Access Compliance Report

Public Rights-of-Way

(Curb Ramps)

| Intersection ID: 29286 | Main Street: FAR_WEST_DR | Cross Street: TULLOCK_CREEK_DR | Location: W |

| ADA ID: 4B8A9D429E0F | Ramp Type: BlendTrans1 | Initial Pass/Fail: Fail | Overall Compliance: No |

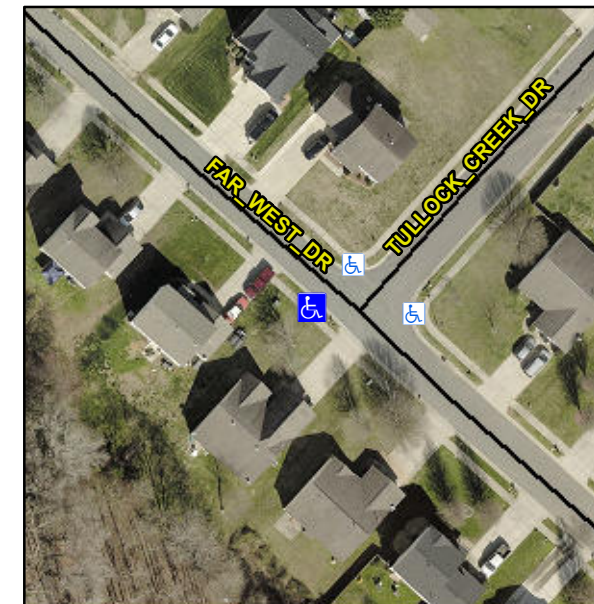
| Severity Score: 8.75 | | | |

Not Found, R304.5.1

| Compliance | Description | Data | Compliance | Description | Data |
|------------|-----------------------|-------|------------|-----------------------------|------|
| No | Ramp Width (in) | 38.5 | Yes | BlendTrans XSlope (%) | 2.0 |

Remove & Replace Curb Ramp With Two New Directional Ramps or Equivalent.
